Contract No. T200411209.01
Federal Aid Project No. ESTP-S028(8)
SR 24, Mulberry Knoll to SR 1
Sussex County

Enclosed is Addendum No. 1 for the referenced contract consisting of the following:

Addendum No. 1
October 24, 2019

SECTION	SHEET NO.
AEC	32

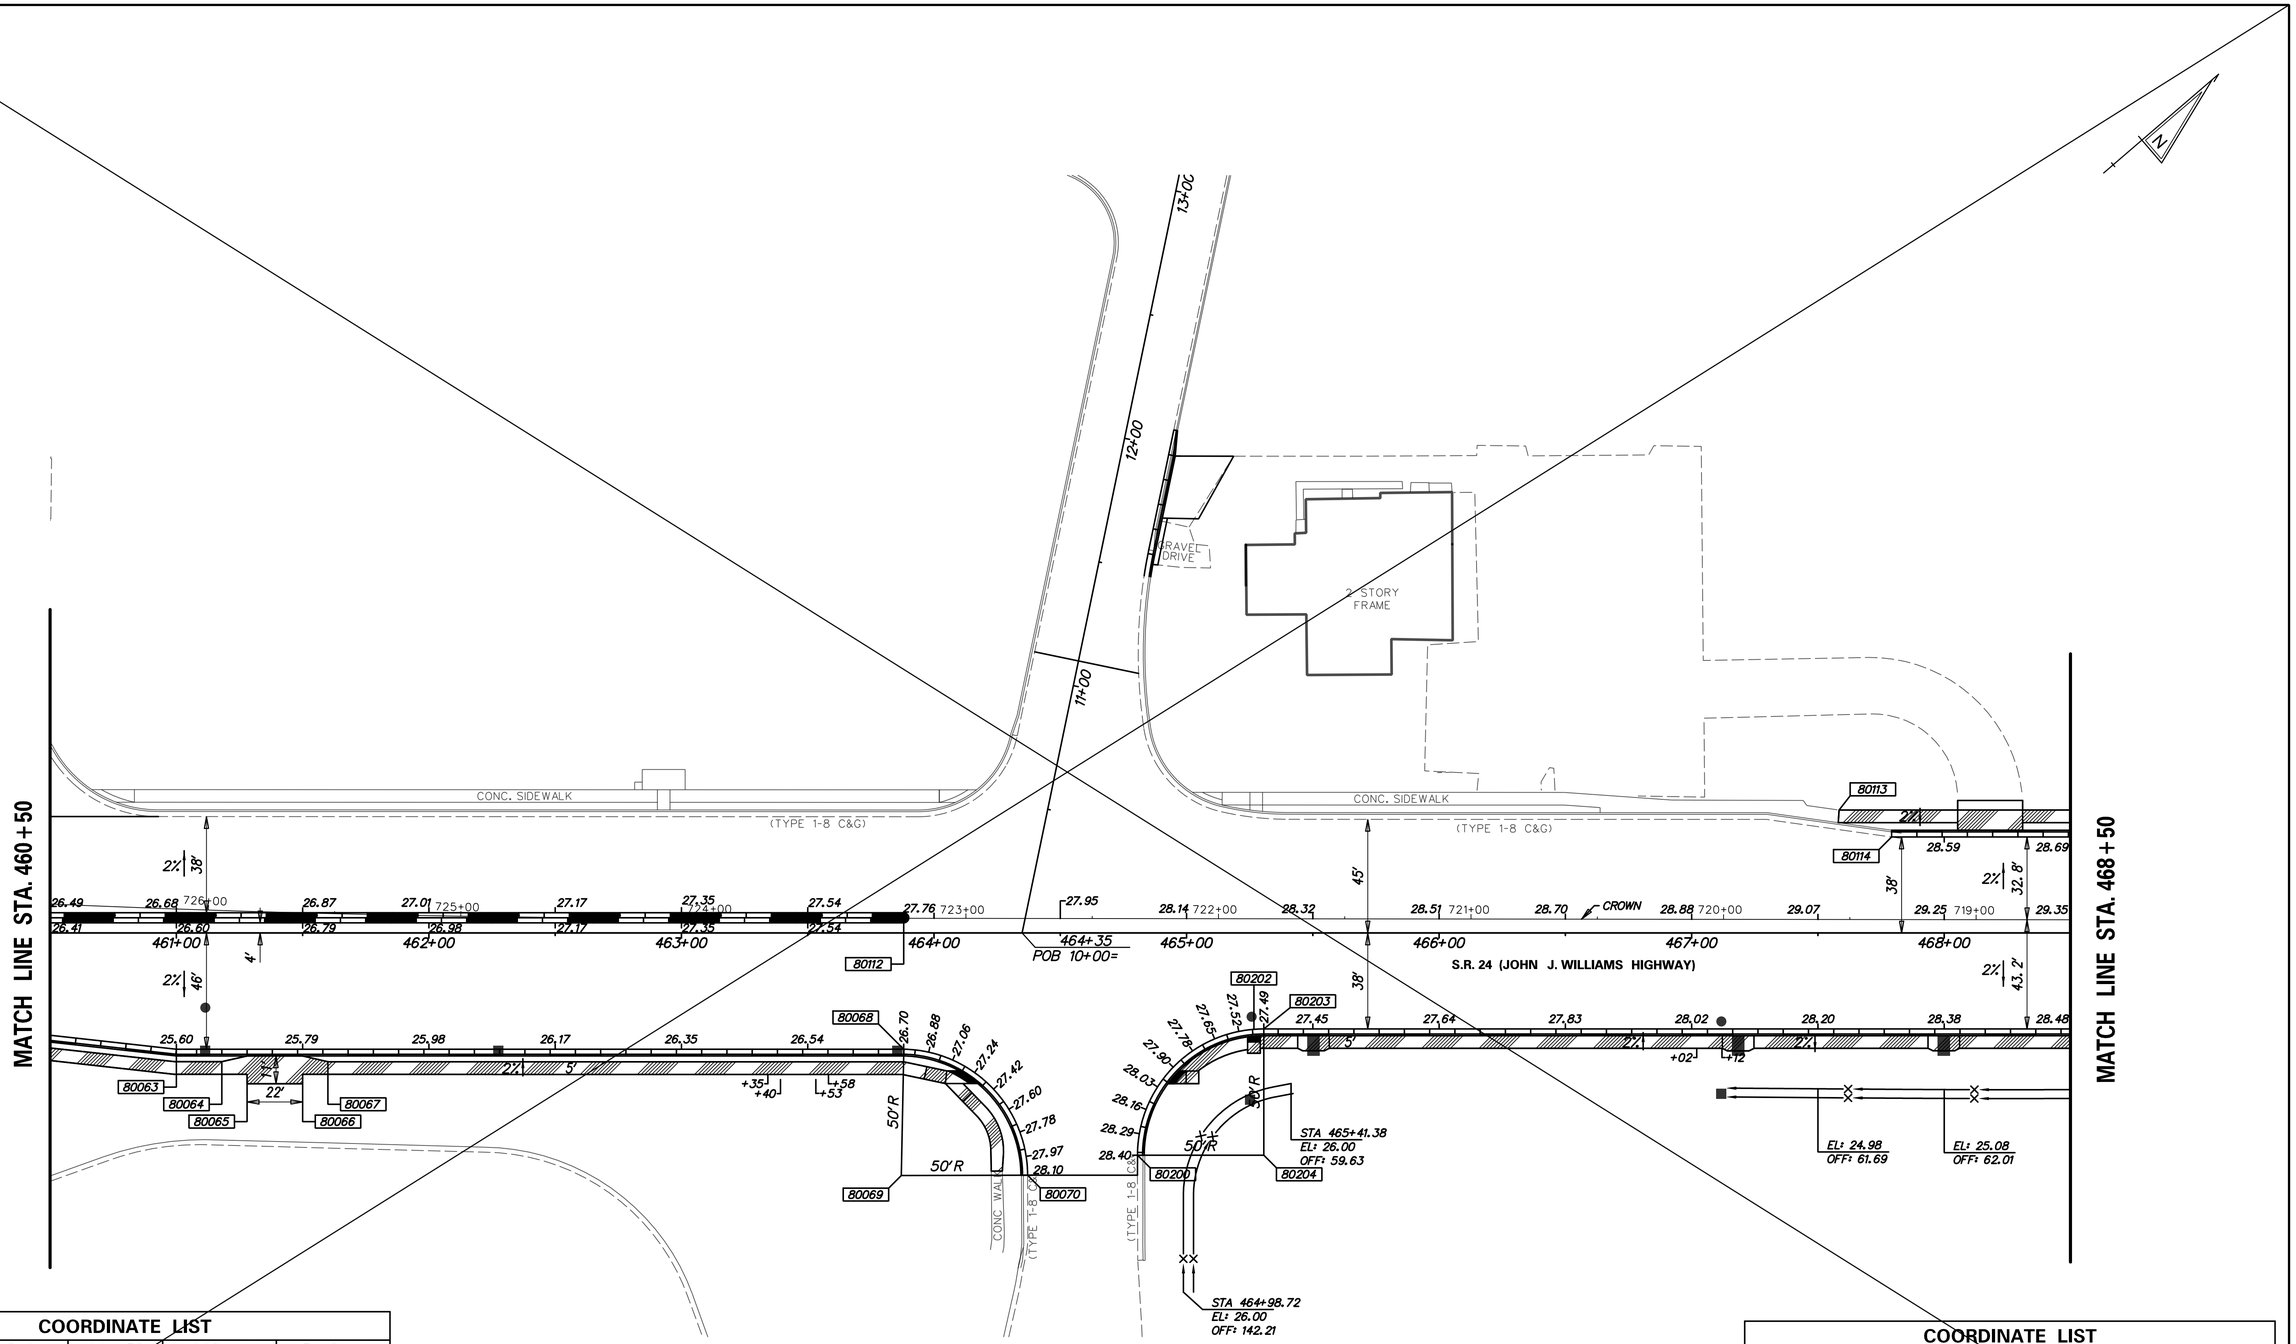
1 REVISED DRIVEWAY LAYOUTS — D. SEMPLE 10/03/2019

SHEET NO. 32A

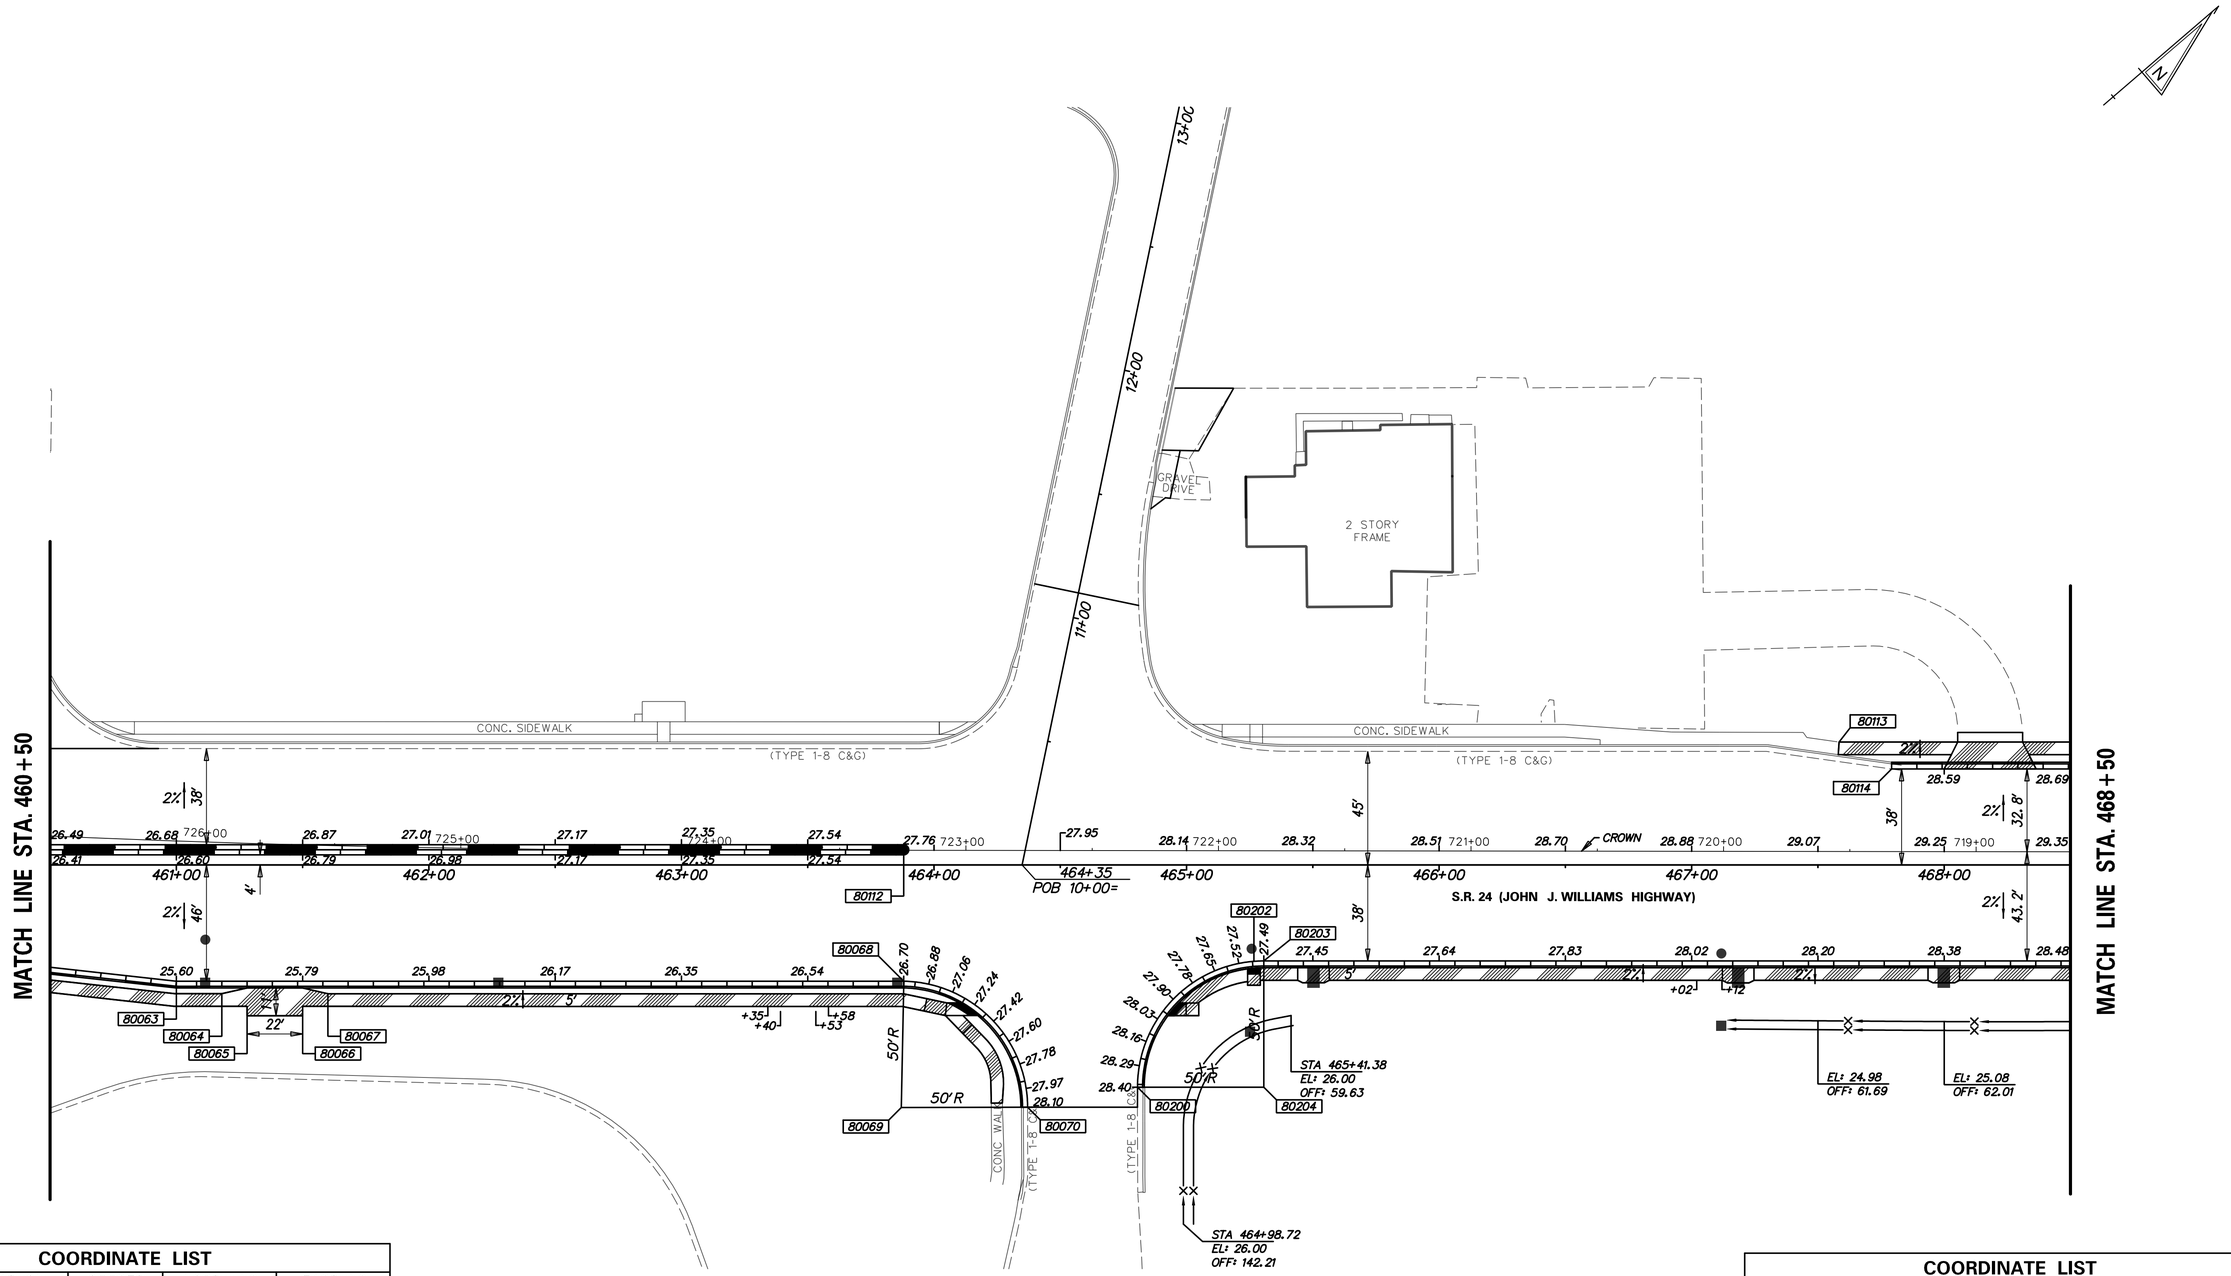
1 REVISED DRIVEWAY LAYOUTS — D. SEMPLE 10/03/2019

⚠ COMPOST FILTER LOG SEDIMENT CONTROL DETAIL

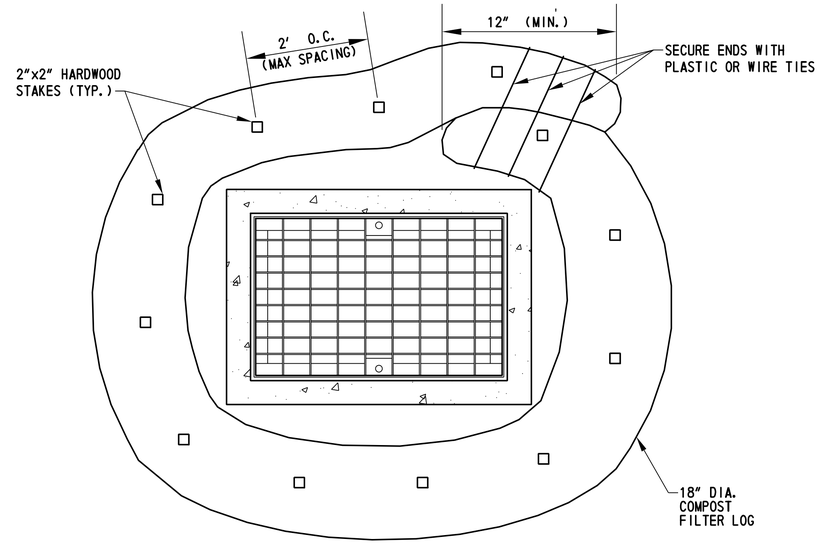
ADDENDA / REVISIONS		
⚠ ADDITIONAL CONSTRUCTION DETAIL	D. SEMPLE 10/03/2019

STORMWATER MANAGEMENT PLAN DELDOT SWM FACILITY ~~#1~~ #1027

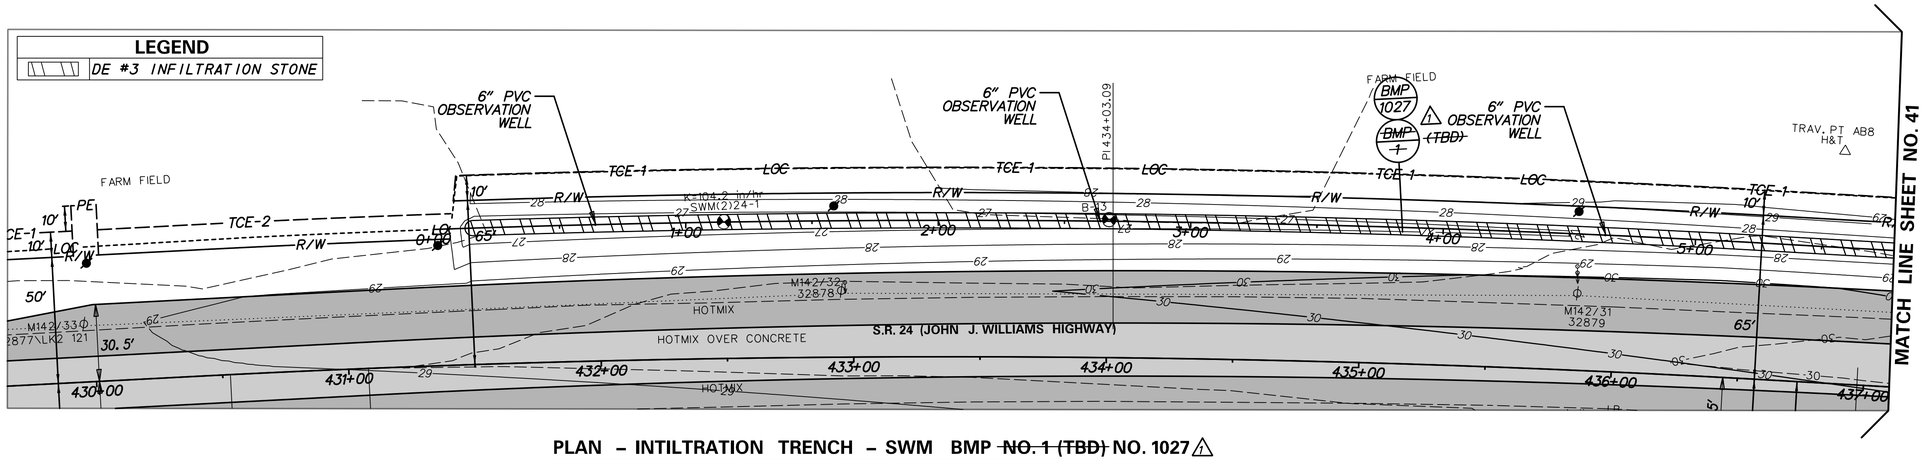
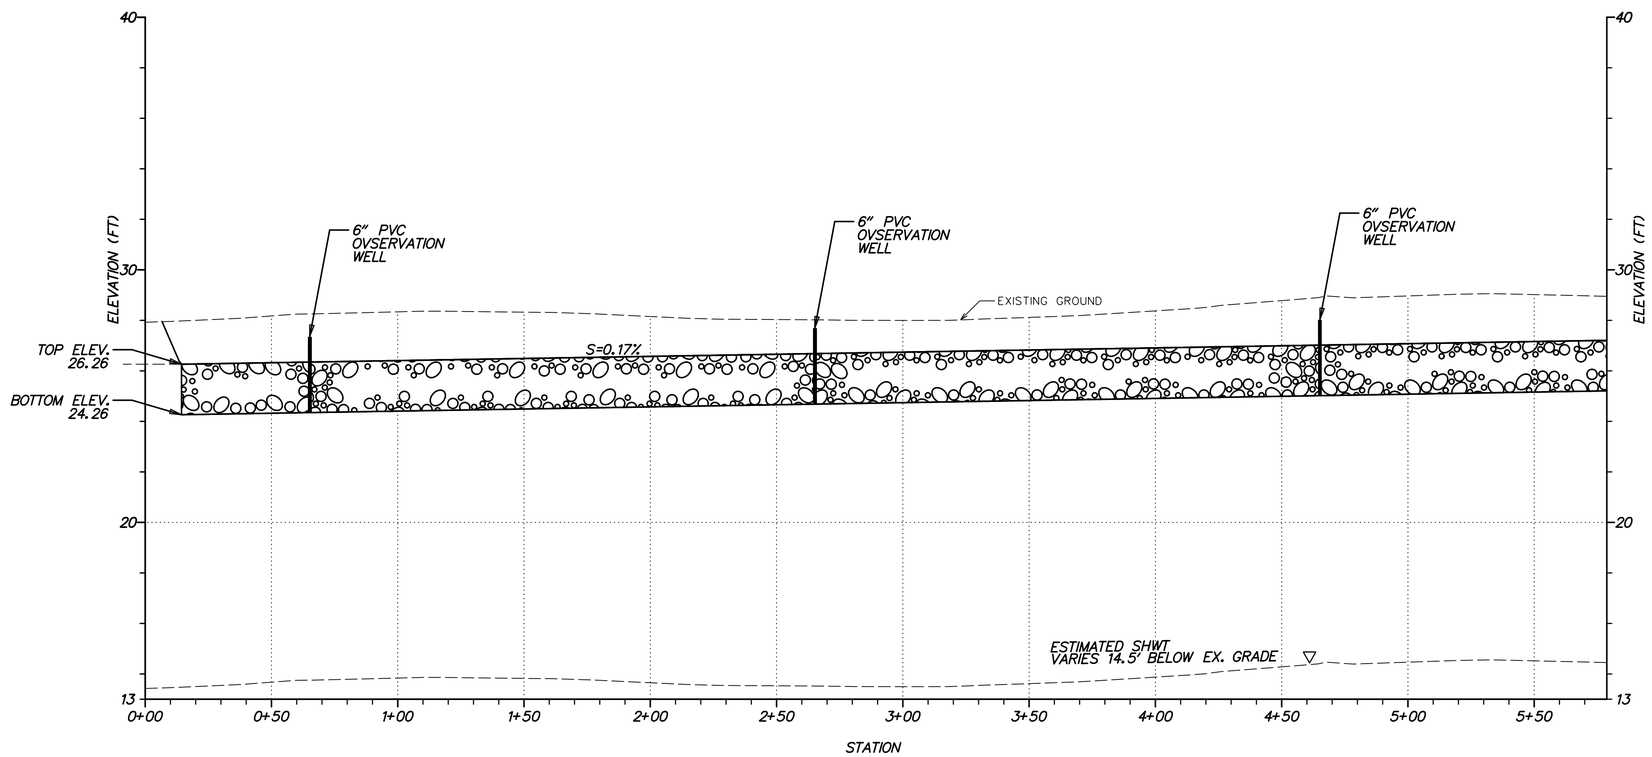
PLAN – INTILTRATION TRENCH – SWM BMP ~~NO. 1 (TBD)~~ NO. 1027

PROFILE – INTILTRATION TRENCH – SWM BMP ~~NO. 1 (TBD)~~ NO. 1027

STORMWATER MANAGEMENT PLAN DELDOT SWM FACILITY ~~#1~~ #1027 △1

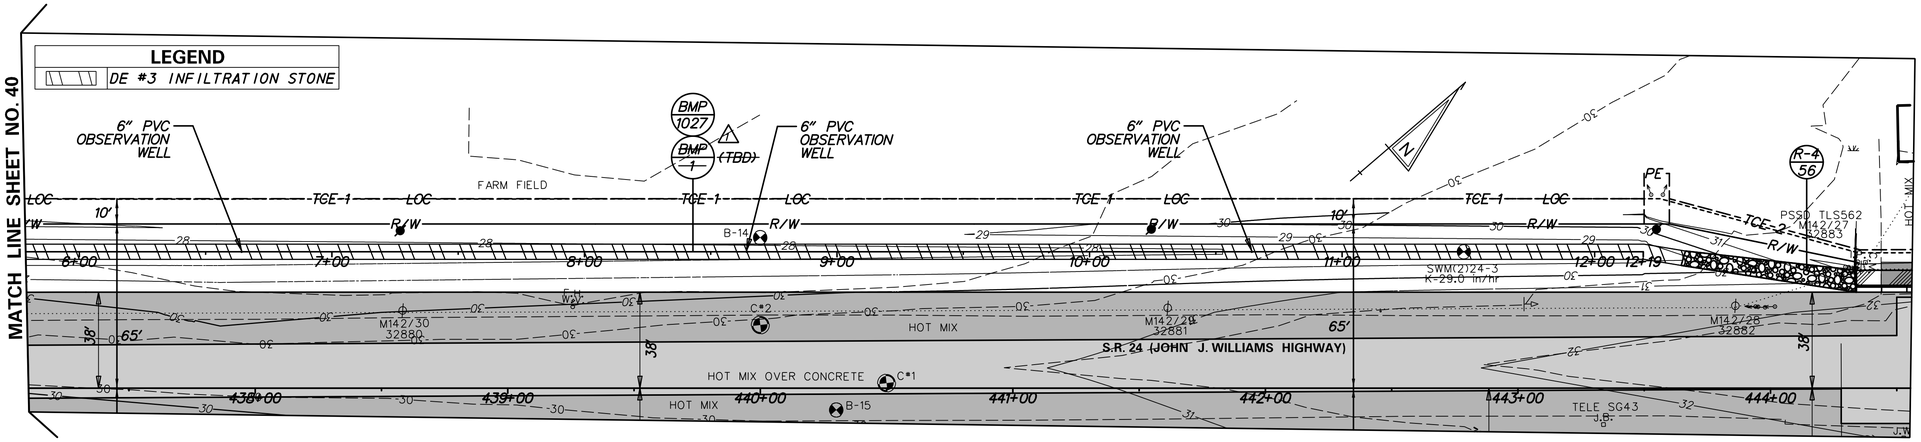
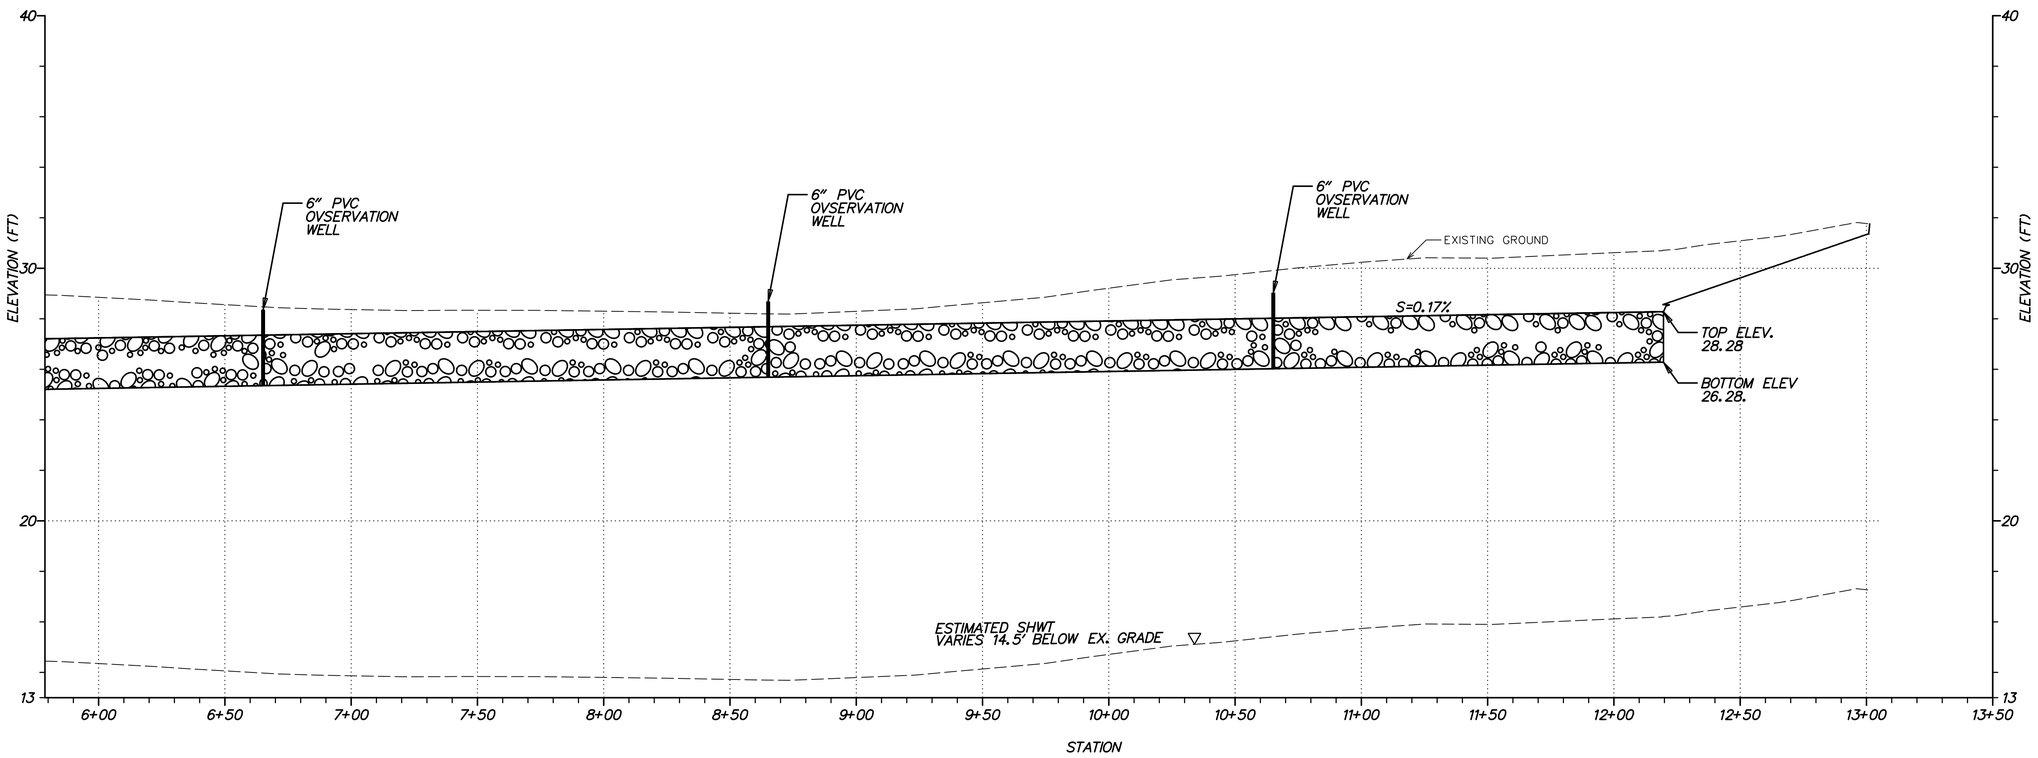
PLAN – INFILTRATION TRENCH – SWM BMP ~~NO. 1 (TBD)~~ NO. 1027 △1

PROFILE – INFILTRATION TRENCH – SWM BMP ~~NO. 1 (TBD)~~ NO. 1027 △1
